**Re: EB-2020-0293 – Enbridge St. Laurent Ottawa North Replacement Project
Pollution Probe Interrogatories to the Applicant**

**Enbridge Gas Inc.
St. Laurent North
Leave to Construct**

POLLUTION PROBE INTERROGATORIES

Reference: EB-2021-0148 Exhibit B Tab 2 Schedule 1 Page 26 of 35

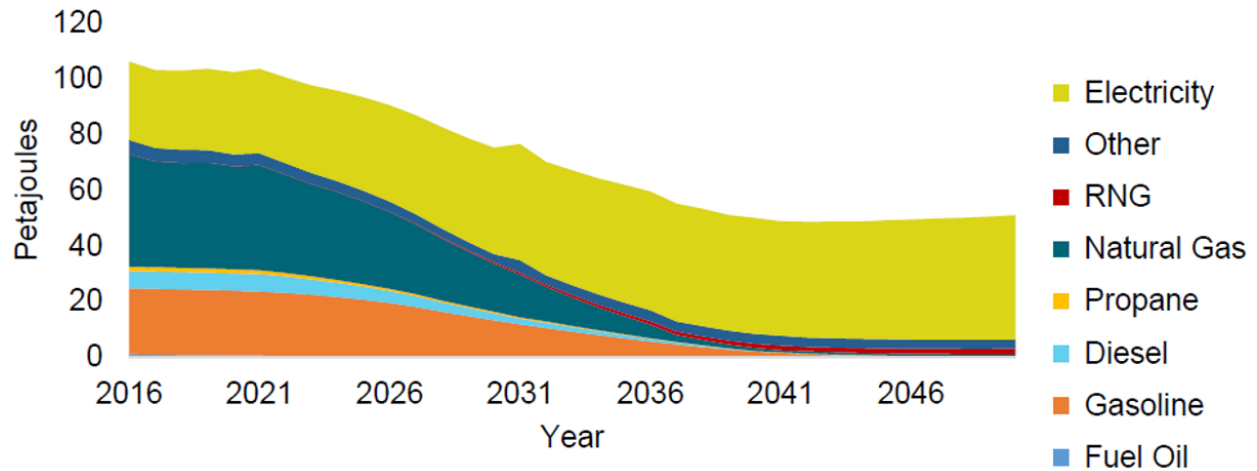
“The project will be completed in multiple phases over multiple years. The existing pipeline services over 165,000 customers in Ottawa, Ontario and Gatineau, Quebec”

- a) Please provide a breakdown of how many of the 165,000 customers are in Ottawa, Ontario and how many are in Gatineau, Quebec.
- b) Please provide the allocation breakdown for pipeline peak demand (m³ and GJ) required to serve the Ottawa, Ontario customers and the same for the Gatineau, Quebec customers.
